Manuscript No.: amt-2013-309

Title: A newly identified calculation discrepancy of the Sunset semi-continuous carbon analyzer

1. Comments in RC C296:

Figure S2. Comparison of TC concentration results given by the newest version (629) of calculation software (TC₆₂₉) and the single-point correction (TC_{SP}), for ambient samples analyzed with (a) IMP_{short}, (b) IMP_{long} and (c) rtNIOSH protocol

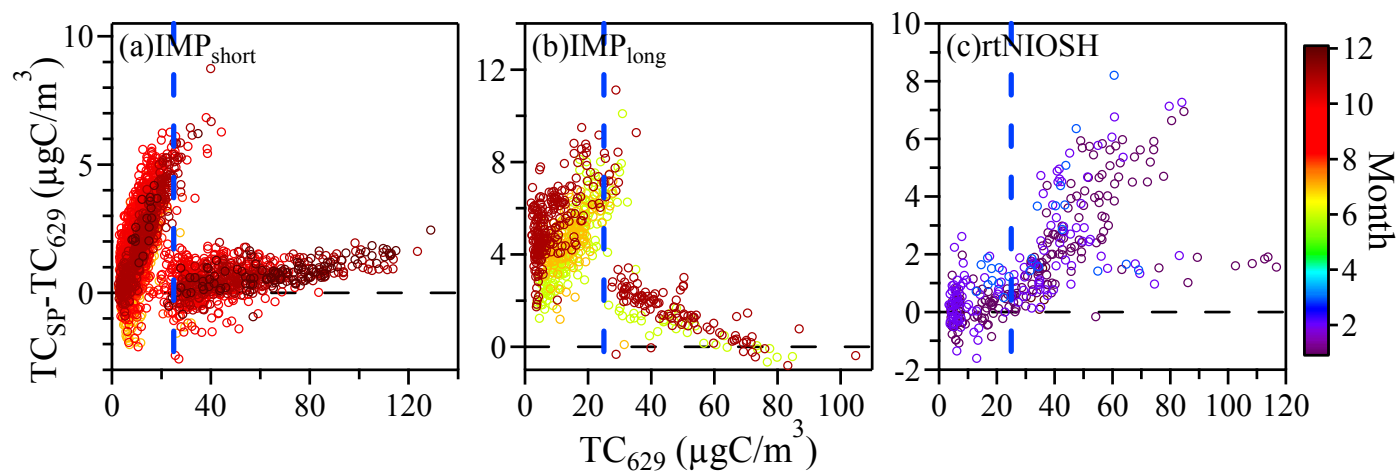
The authors discovered an error in an older version of the calculation program, which had been designed for the NIOSH method at the time, not meant for the IMPROVE method. Rather than do such an extensive study, it would have been better to simply contact the manufacturer to either alert them, or obtain a current corrected version. In fact, toward the end it appears they did this, yet only presented the results with no comments.

Furthermore, the current version of calculation software could not thoroughly solve this calculation discrepancy, even with the NIOSH-like temperature protocol. As shown in Fig. S2, the current calculation program used a piece-wise baseline correction methods. When total carbon concentration determined by multi-point correction method exceeded a determined threshold concentration ($\sim 25 \mu\text{gC}/\text{m}^3$), the baseline correction method changed from multi-point method to a new method similar to single-point method. However, the arbitrary choice of the threshold concentration was the problem. As we have explained in the manuscript, threshold carbon load could vary with temperature protocols as well as sample types. For the two IMPROVE-like protocols the threshold was too large (Fig. S2). For rtNIOSH protocol, we supplemented some experiment of summer ambient samples (Fig. S3). Supplementary sampling was conducted from June 1st to August 31st in 2013, with rtNIOSH protocol and time resolution of 1h (40 min sampling + 20 min analysis). As can be seen from Fig. S3, for rtNIOSH protocol, the threshold carbon load was significantly lower in summer (close to zero) than in winter ($\sim 25 \mu\text{gC}$). Although the current calculation program performed better for winter samples, it failed to identify and correct the calculation discrepancy in summer samples. Thus we recommend that **the occurrence of this calculation discrepancy should always be checked** when this instrument was applied to new temperature protocols or ambient samples with unknown distribution of thermal stability. **This part of discussion was also added in the revised manuscript (See the last paragraph in Section 3.4, Line 374~391).**
